CALIFORNIA COASTAL COMMISSION

CDP NO. 5-18-0394 (FARIBA AND MORTEZA DANESH)**MARCH 6, 2019****EXHIBITS**

GEOTECHNICAL REVIEW MEMORANDUM

To: Mandy Revell, Coastal Program Analyst
From: Joseph Street, Senior Environmental Scientist
Lesley Ewing, Senior Coastal Engineer
Re: 449 Paseo de la Playa (Danesh Residence), CDP Application #5-17-0134

Exhibit 1– Commission staff’s determination of bluff edge compared to that the applicant.

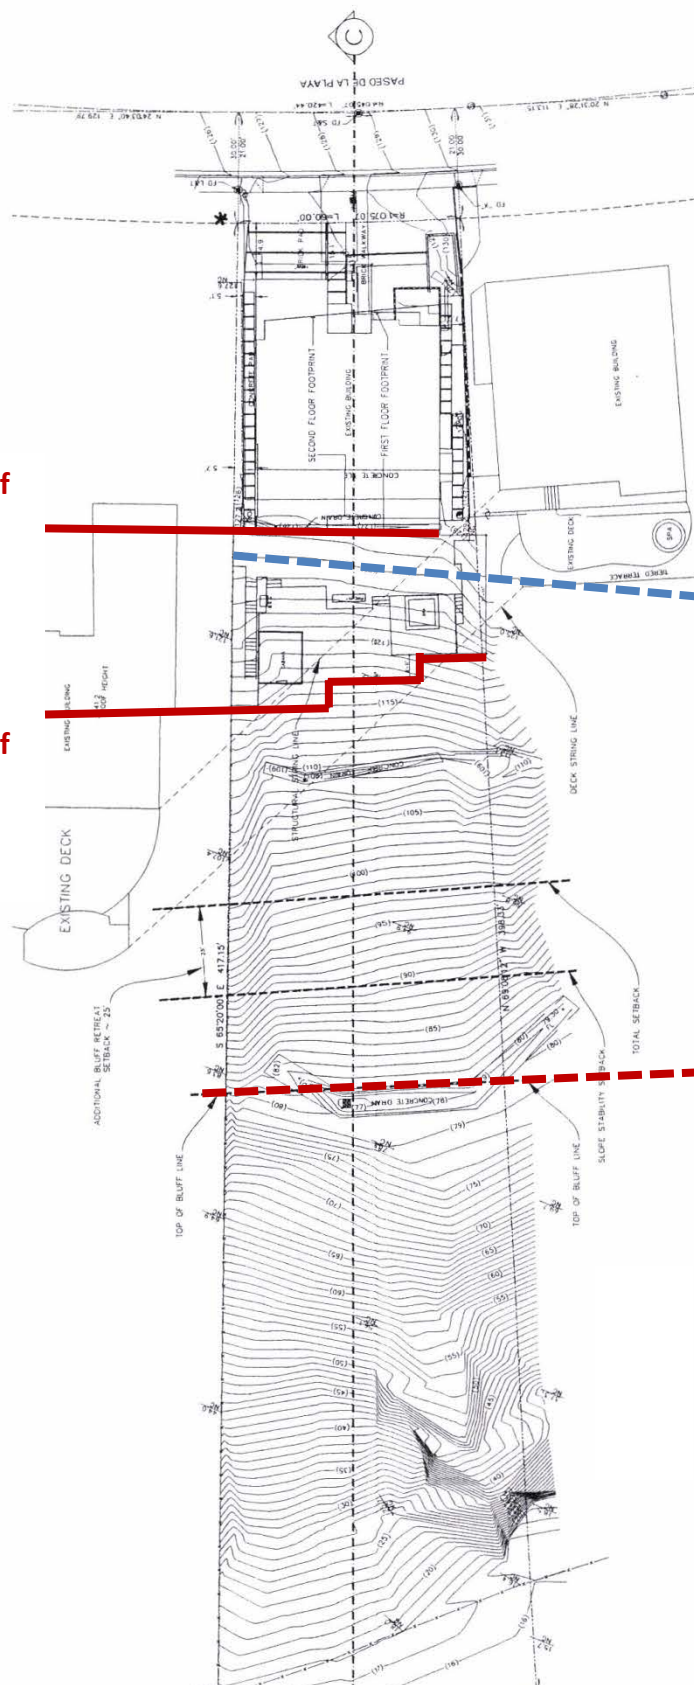
**Commission Staff's Bluff
Edge**

**Applicant's Bluff
Edge**

Attachment 1: Geologic Section C-C' (Updated 1-22-18; from Bluff Edge Determination Study by Hamilton & Associates.

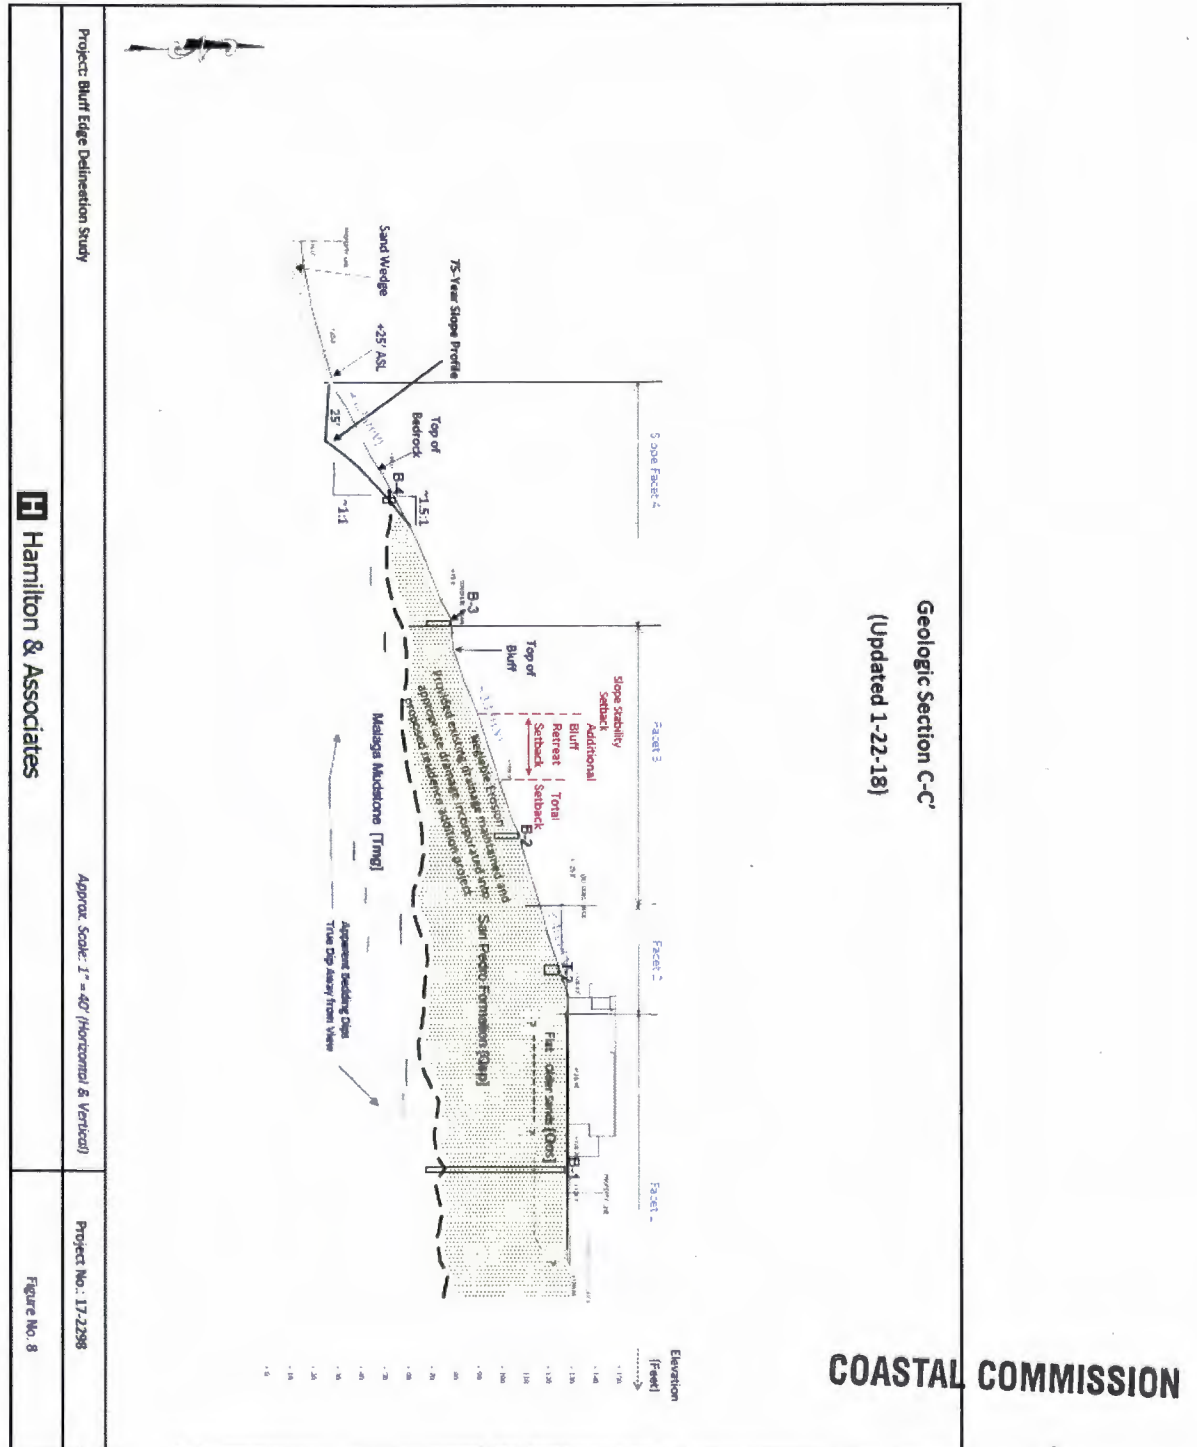
In contrast, the applicant's geotechnical consultant identifies a "top of bluff line" roughly halfway down the bluff slope at an elevation of approximately +80 feet MSL (approximately 50 feet below the elevation of the existing house). Though not explained in reference (3), this positioning of the top of bluff line appears to rely on a localized decrease in the gradient of the slope occurring near the lowermost concrete swale built into the face of the bluff. While the natural, unaltered shape of the bluff at this location is unknown, this slope transition was part of the slope restoration (Ref. 5) and is a manufactured feature placed in the middle of the bluff slope to provide for safe site drainage. Regardless of the origin of this swale, the Commission's bluff edge definition expressly accounts for this sort of small-scale, localized variability in slope through its stipulation that the gradient increase only *more or less* continuously, rather than *strictly* continuously, and through its guidelines for addressing "steplike features" on the bluff face. At most, the applicant's "top of bluff" corresponds to just such a steplike feature, but one that is part of a nearly continuous slope that rises approximately 50 feet more (i.e., another "riser") before reaching clearly apparent slope transition to the level area upon which the existing house has been constructed. In conclusion, the applicant's top of bluff line does not represent the position of the bluff edge as defined by Coastal Commission regulations.

The applicant’s consultants have estimated long-term retreat of the lower bluff (**Attachments 1 & 2**, “Facet 4”) of approximately 20 feet between 1924 and 2017, based on an analysis of recent and historical aerial photographs (to 1952) and a 1924 USGS topographic map (Ref. 3). Accounting for measurement uncertainties, they suggest an upper-bound long-term retreat rate of four inches per year. While acknowledging the likelihood of future sea level rise over the

Attachment 2: Site Topography- Site Section, Sheet A 1.2, prepared by bijan & associates for
449 Paseo de la Playa, Redondo Beach, CA 90277

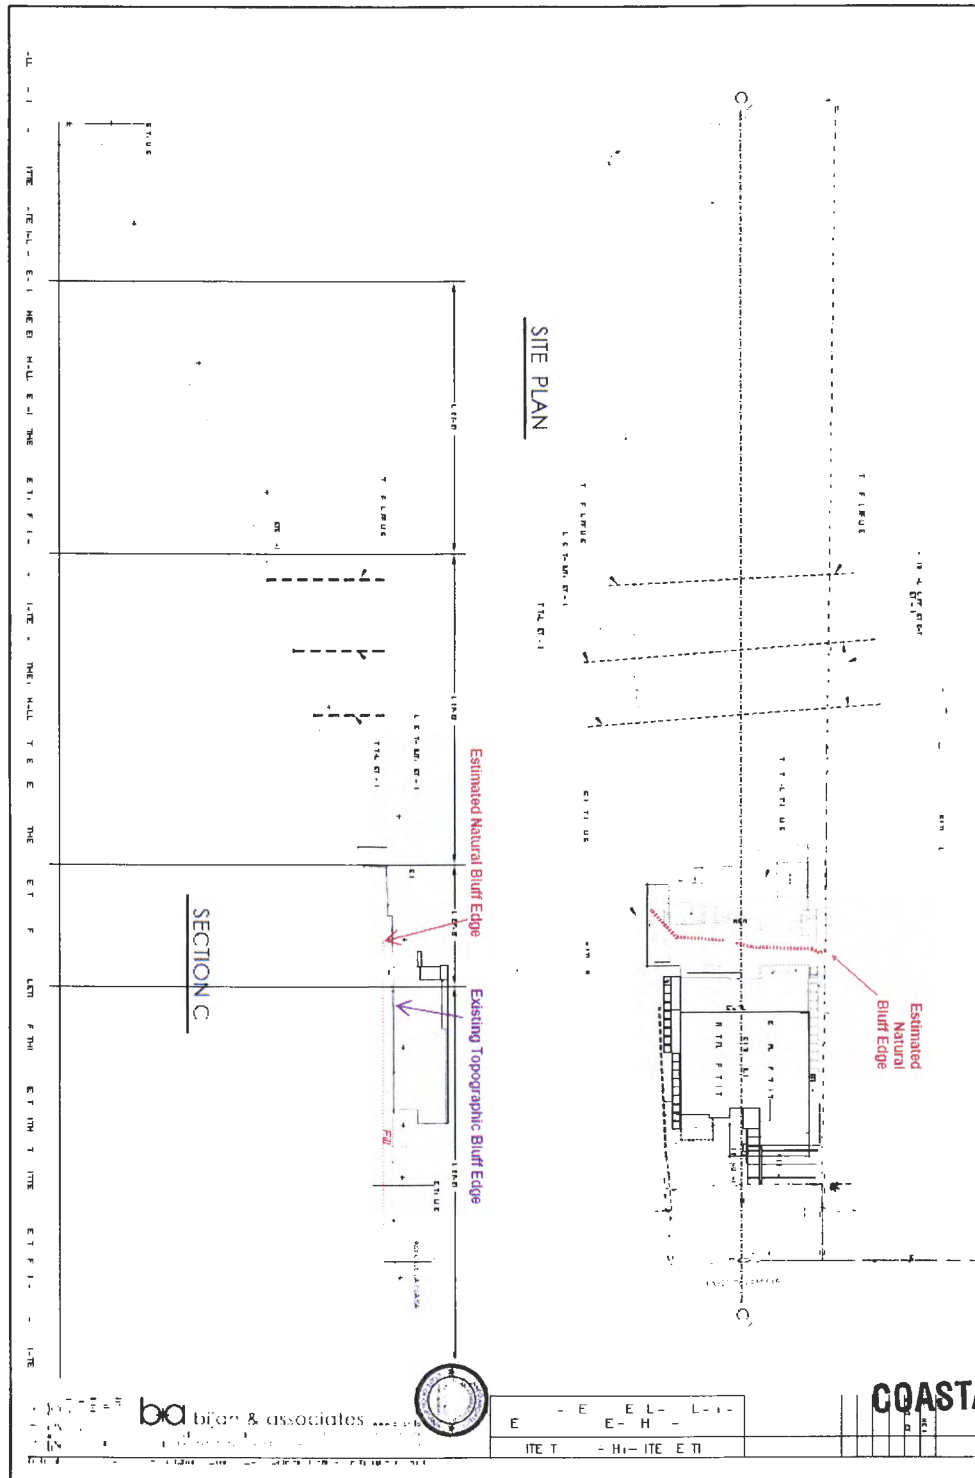
The terrace deposits of the upper bluff slope are susceptible to subaerial erosion, as evidenced by landslides and slope failures along the bluff south of the project site, and by previous surficial slumps occurring on the upper bluff at the project site itself (Refs. 3, 5, 6).¹ Three existing concrete swales that traverse the bluff slope at the project site (at elevations 127 ft, 100 ft, and 75 ft MSL) were required as a permit condition the Commission’s 1990 approval of the slope restoration (Ref. 5). The upper bluff face is characterized by relatively gentle slopes of 25 to 33% (4:1 to 3:1, horizontal:vertical) (*see Attachment 2*).

Without the collection of additional, site-specific information, the natural bluff profile and bluff edge line at the project site cannot be accurately reconstructed. However, a conservative assumption, which accounts for the available data on fill depth and is in keeping with the previously-determined natural bluff edge at a neighboring site, is that the natural bluff edge line is approximated by the +125 foot elevation contour (see **Attachment 2**).

Our previous memorandum identified the edge of the coastal bluff as the +125 foot elevation contour (see **Attachment 2** of February 20, 2018 memorandum), based the bluff edge definition contained in Section 13577(h) of the Commission's regulations¹, and taking into account the modified nature of the bluff at this site. The information available to us indicated that the natural bluff was substantially altered first in the 1960s, when this stretch of Paseo de la Playa was first developed, and again in

Figure No. 2c

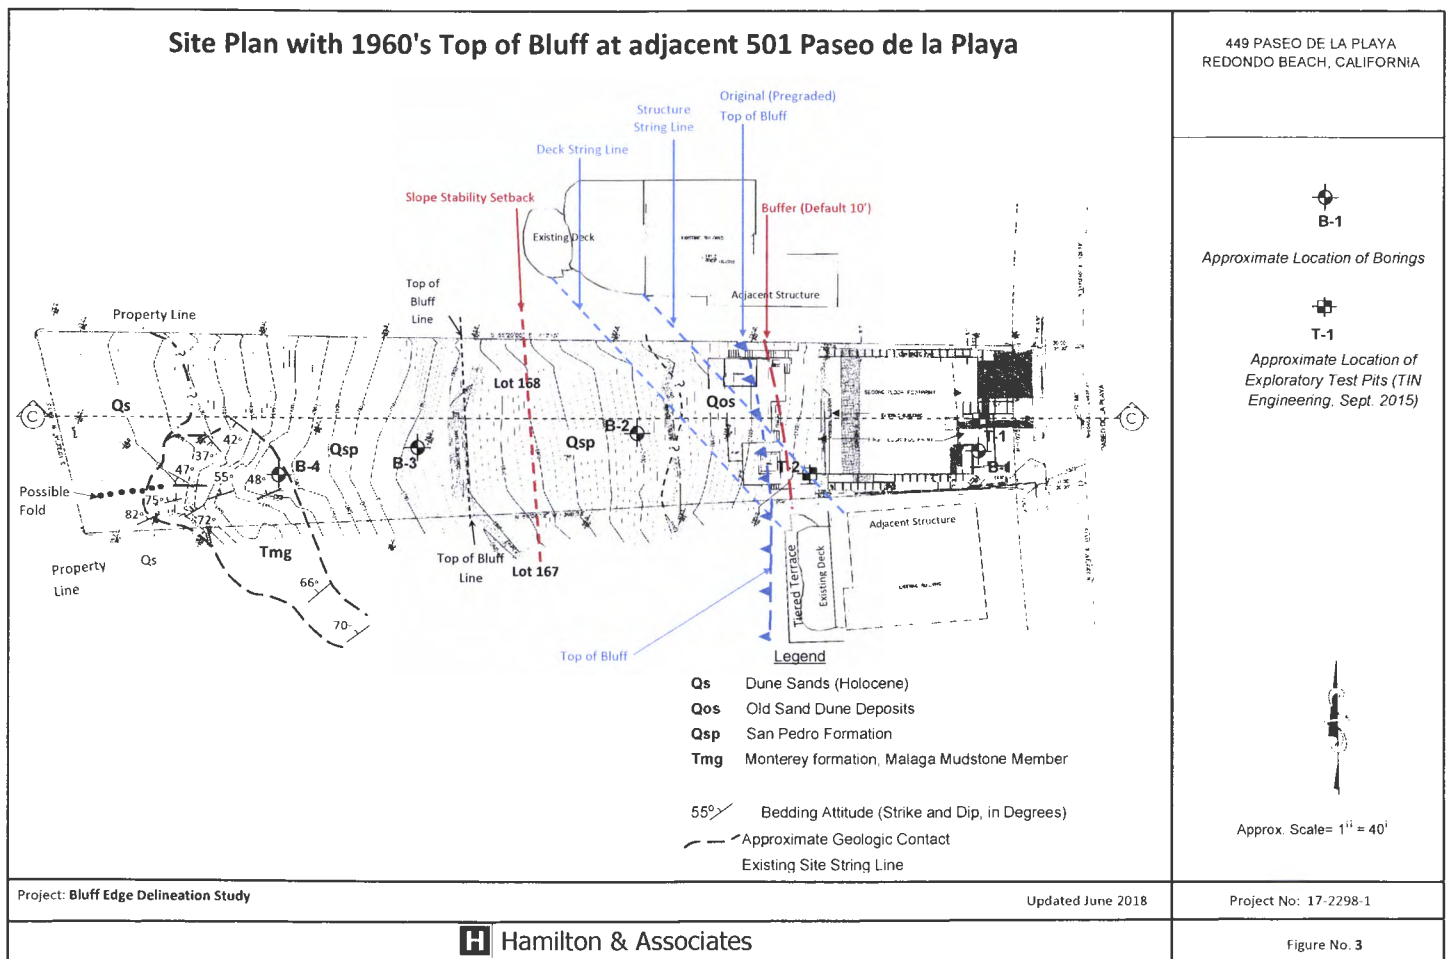
- The 1990 Commission approved slope restoration plans (Ref. 5, Exhibits 2 and 3) show a 30 inch fill blanket at the building area at the uppermost part of the slope. In addition, there is a slight rise seaward of this blanket for the intersection of the flat building area and the slope face. The plans are not of sufficient detail to provide an estimate of this rise, but this could increase the 30 inch thick fill blanket to approximately 36 inches at the slope intersection. This would decrease the elevation of the slope intersection, prior to the constructed fill by approximately 3 feet.

Figure No. 4

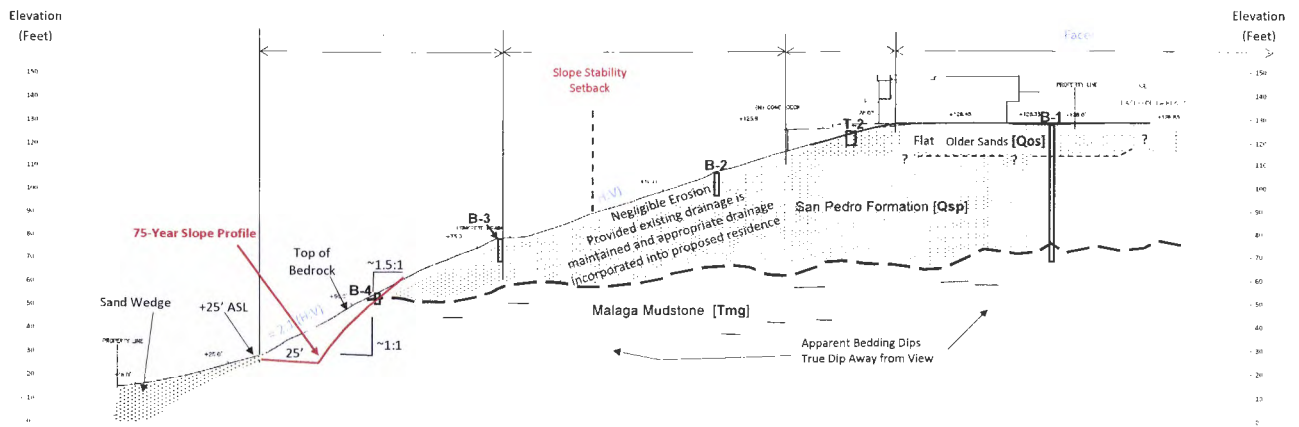
For informational purposes, the “historic (pre-graded) bluff” is provided on the attached Site Plan and Cross Section (**Figures 3 and 4**). Due to being a “cut” lot, the Historical Bluff is located at approximate elevation 125 feet above MSL only at the point where it intersects the property line with the neighbors (501 Paseo de la Playa) and pulls downslope from that contour as the historic bluff crossed the subject lot (449 Paseo de la Playa).

b) Slope Erosion Setback: A negligible Long-Term Bluff Retreat (LTBR) between 1992 and present (2017), as documented in H&A report dated July 3, 2017, is to be noted. This represents the time from the slope improvements. Hence, very little retreat has occurred after slope improvements (namely, after installation of lateral bench drains, slope angle reductions). Further, past slope improvements have considerably reduced LTBR. The good condition of the 1990 improvements at the site is to be noted, representing a period of approximately 27 years, which also give testimony to the slow LTBR. A slope angle of approximately 34 degrees (pre-grading 1.5:1 [H:V] average slope gradient), further pointing to the favorable 18 to 19-degree slope angle (graded 3:1 [H:V] average slope gradient), now current, as shown on **Figure 4**.

The outcropping of the Malaga Mudstone [Tmg] is about 25 feet above current mean sea level, as shown also on **Figure 4**. Assuming the absence of the sand shown on the cross-section, erosion of the toe of the Malaga Mudstone, as shown on the cross-section, would logically require more than 75 years to produce a 1:1 (horizontal to vertical) slope as shown in the cross-section, yet it is assumed herein.

as well as our previous discussions and correspondence with CCC Staff. Consequently, a default buffer of 10 feet, is deemed in compliance with current CCC regulations, adequate for the subject site, as shown on **Figure 4**, rather than the 25 feet set back previously considered by CCC Staff for this site (449 Paseo de la Playa). Namely,
